ADDENDUM NO. 2 July 17, 2019 225346

RE: TOWN OF ROCHESTER, VERMONT

BETHEL MOUNTAIN ROAD REPAIR ER 0176(11)

FROM: DuBOIS & KING, INC.

SHEET 5 OF 77

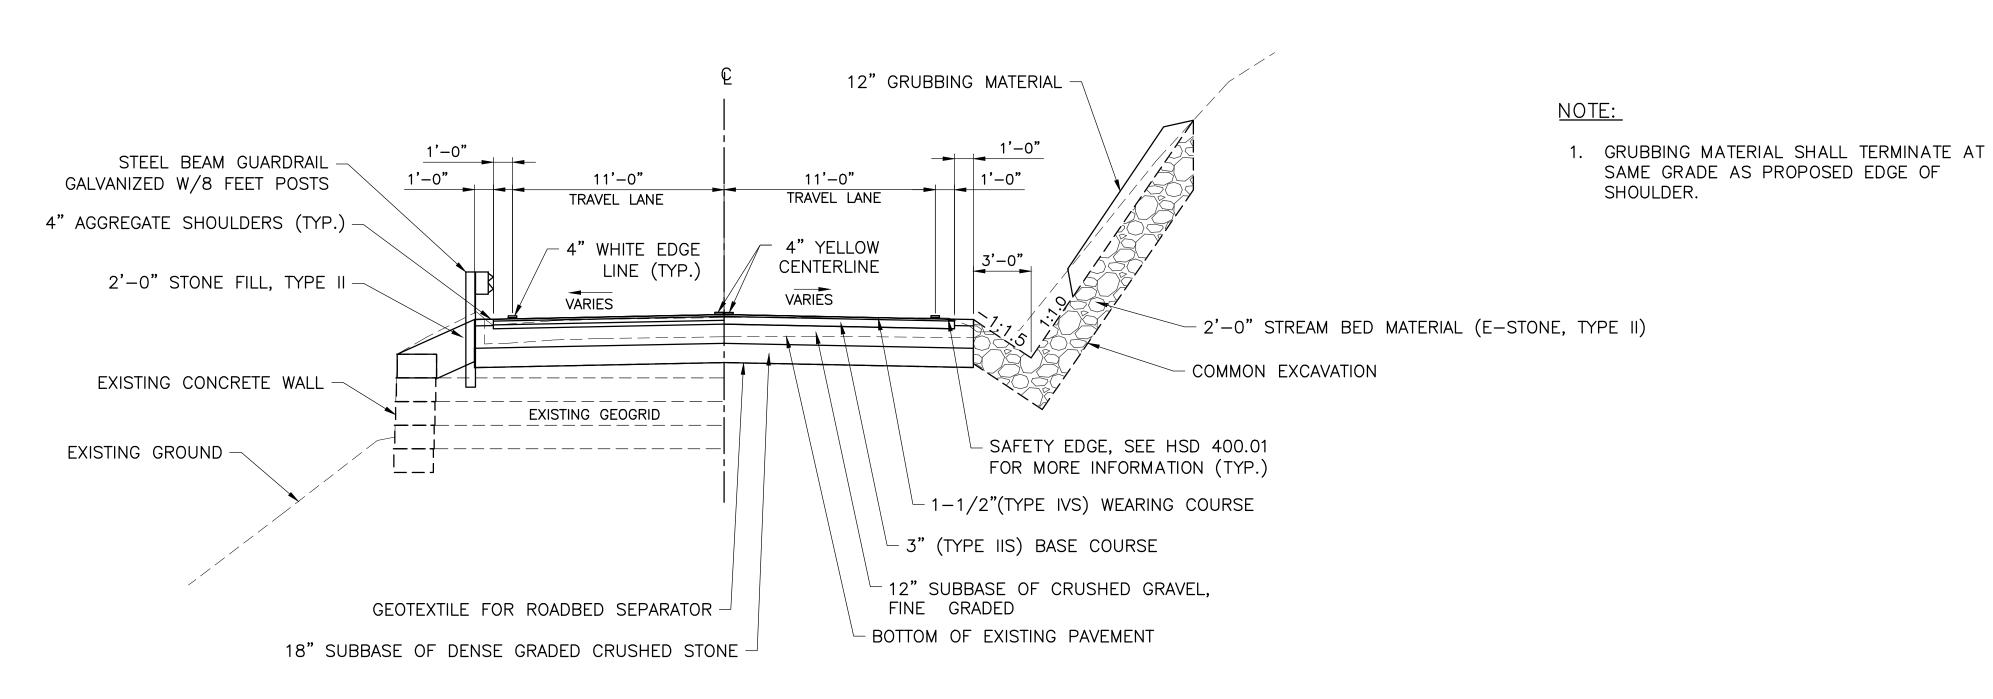
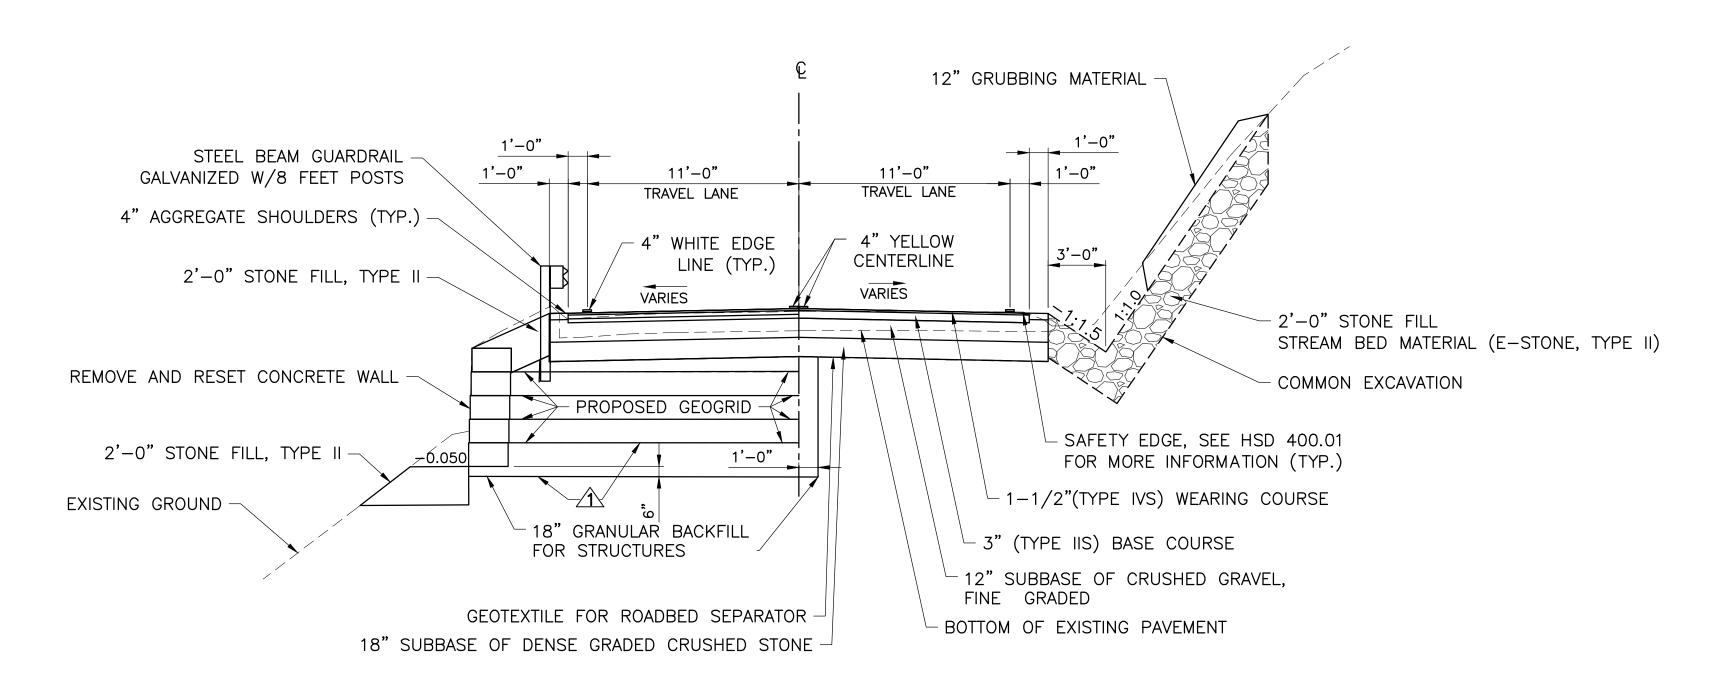
,	*	* 1	7111	1111	17.0	
JBA						RY CK'N
BMB						Α
7/16/2019 CONC. WALL PAY LIMIT MODIFICATION BMB JBA						NOITGIACORIDA
7/16/2019						JT A C
1						ON

REMOVE AND RESET CONCRETE WALL DETAIL - ELEVATION

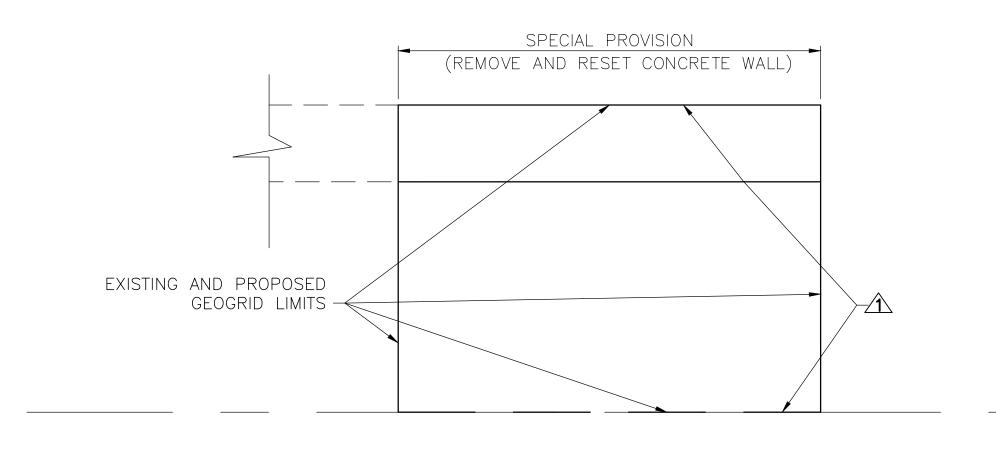
JBA				BY CK'D
BMB JBA				ВУ
GEOGRID MODIFICATION				DESCRIPTION
7/16/2019				DATE
_				NO.

<u>900.645.02. MATERIALS</u>. All existing hardware is intended to be re-installed, defective hardware and attachment materials shall be replaced. Existing geogrid to be cut and replaced with new geogrid, Tencate Miragrid 5XT or equal.

<u>Answer 30</u>: The concrete block wall is to be removed and reset as shown on the plans, to include new geogrid. The Contractor is to provide a submittal for D&Ks acceptance of the product. The geogrid used in the existing concrete wall is Tencate Miragrid 5XT.

SHEET 28 OF 77

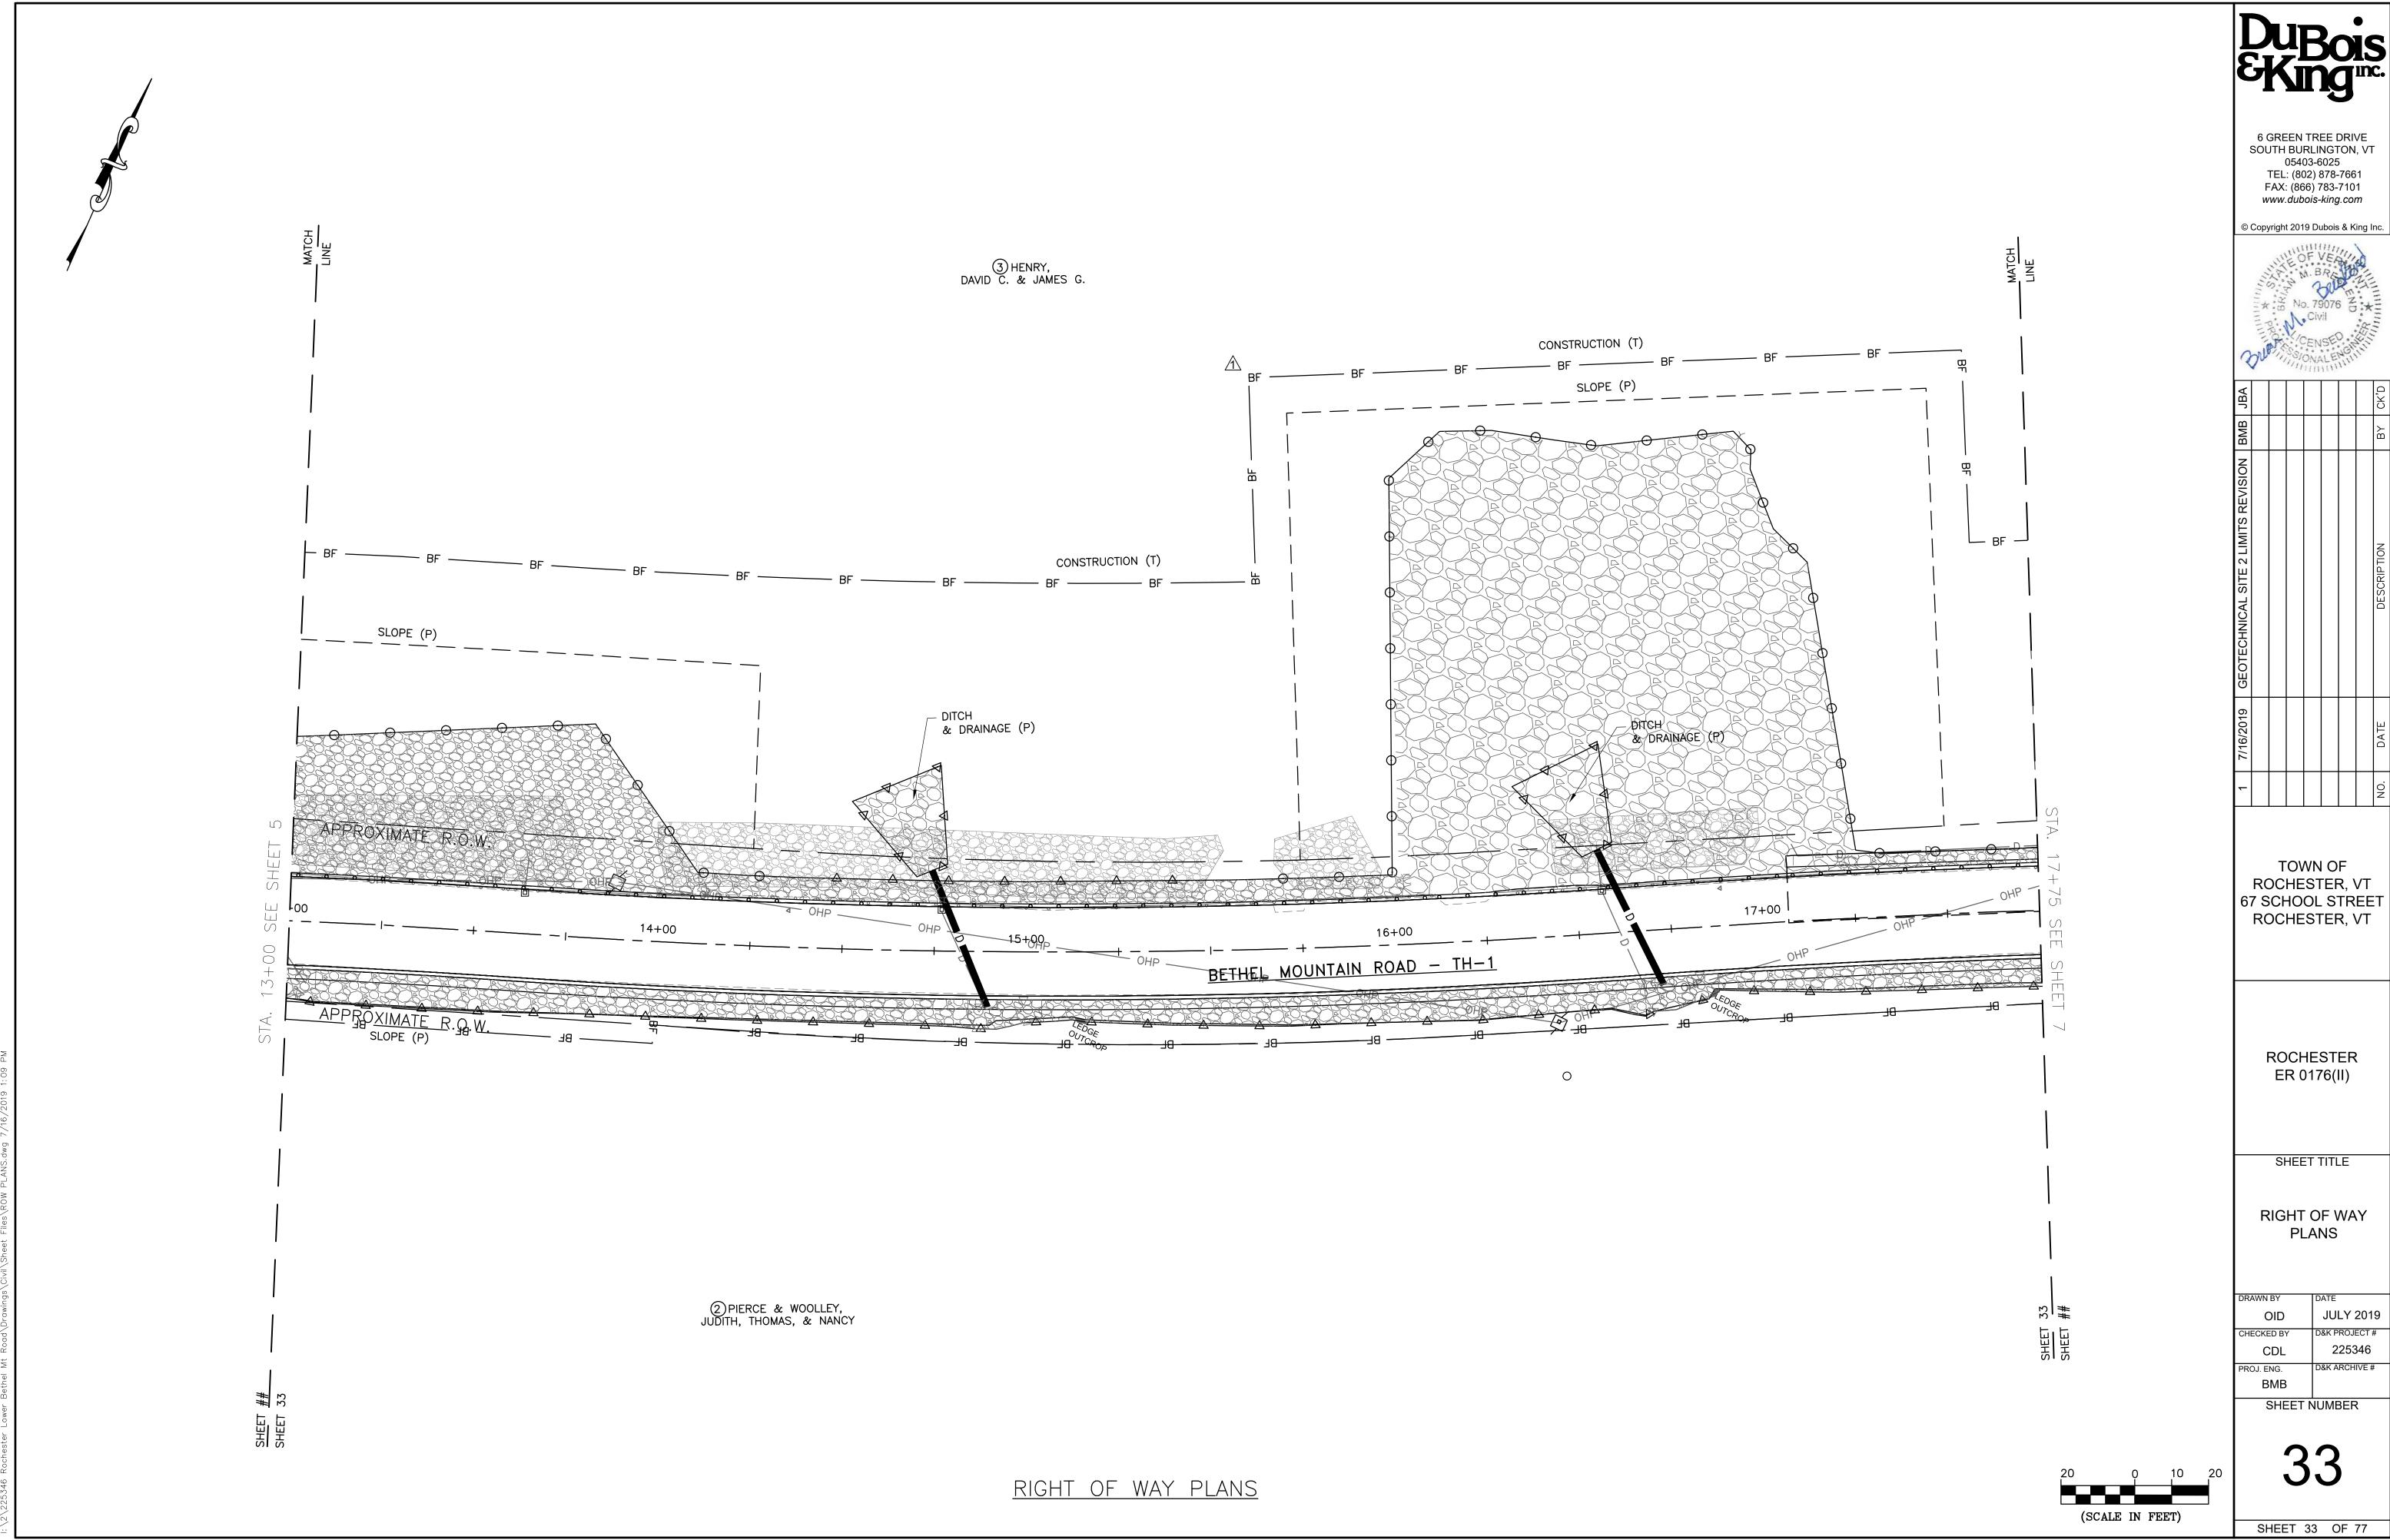
Question 7: In Reviewing the concrete and rebar quantities on the Drainage Detail Sheet for the culvert headwalls, the rebar and concrete amounts do not seem to match the quantities shown on D-33. Nor do they seem to be consistent on this Drainage Detail Sheet. For example, Culverts 19 and 20 are both 18" dia, but the headwall concrete varies from 9.61cy to 2.85cy. Culvert 18 is a 42" dia culvert and only has 2.05cy of concrete. According to D33, an 18" culvert should be about 2.05cy and the 42" should be about 8.2cy. Can you please clarify?

Answer 7: See attached revised **Sheet 28**.

SHEET 47 OF 77

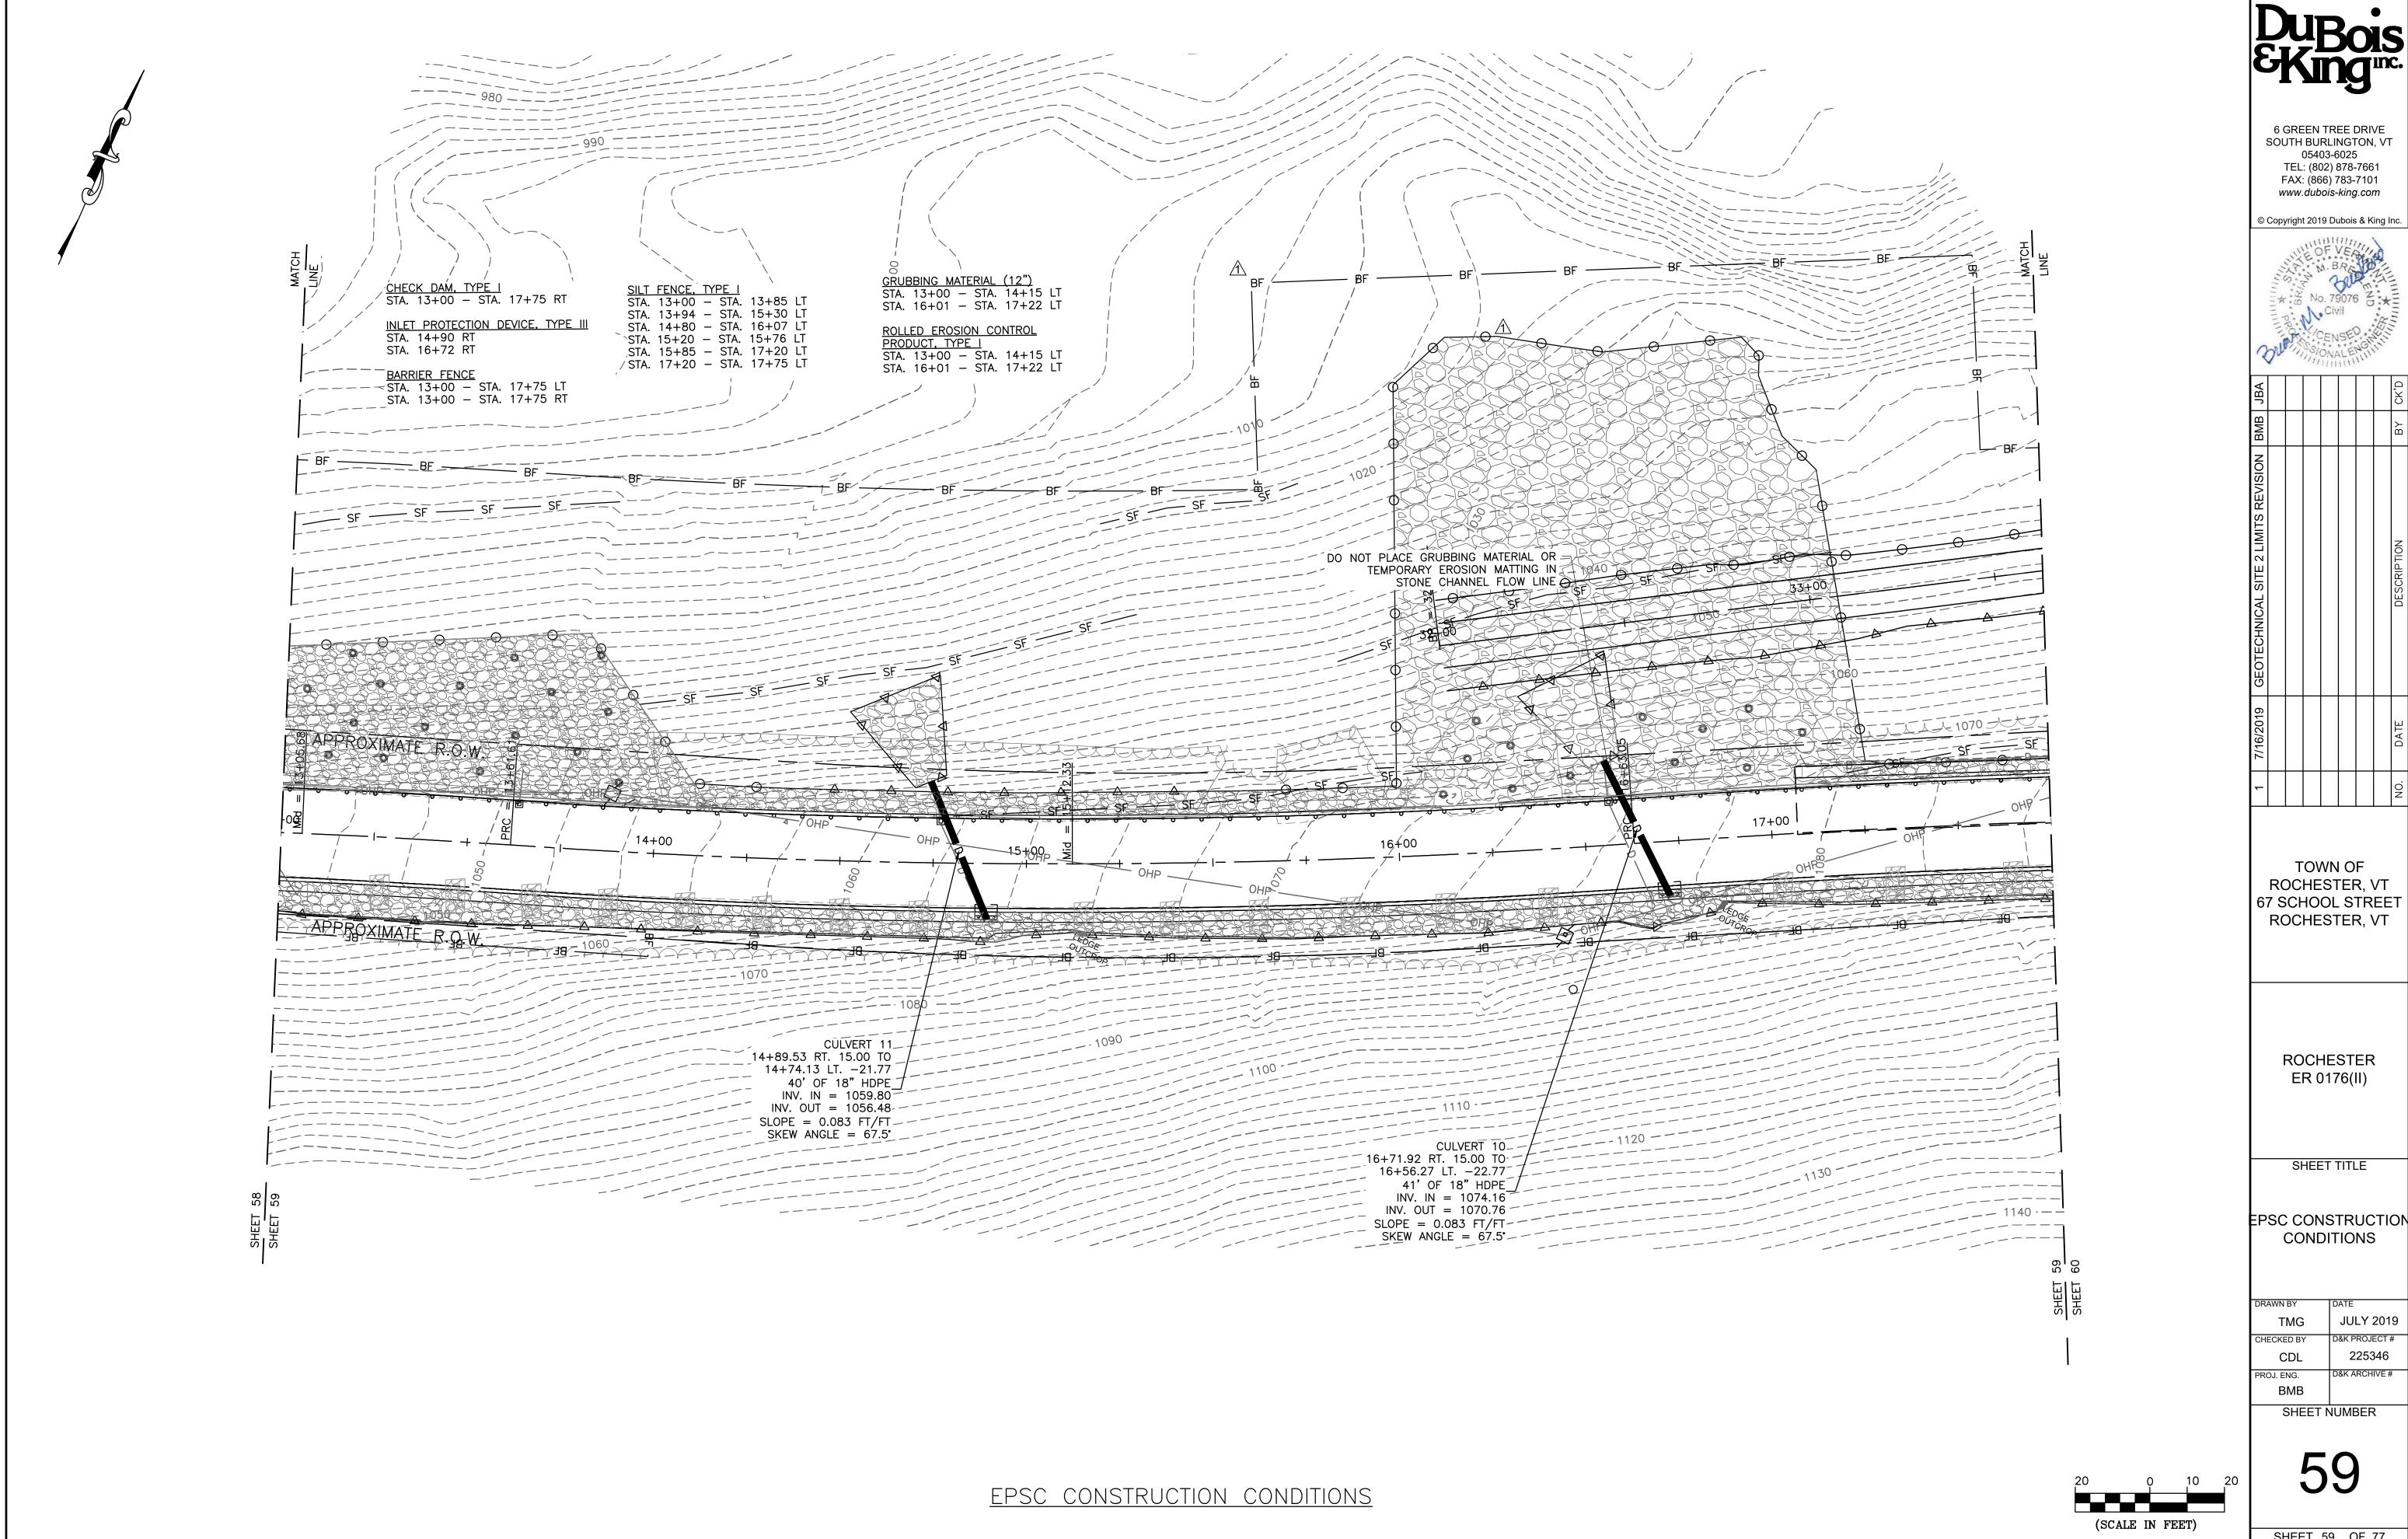
JBA				BY CK'D
BMB				ВУ
7/16/2019 GEOTECHNICAL SITE 2 LIMITS REVISION BMB JBA				DESCRIPTION
7/16/2019				DATE
7				.ON
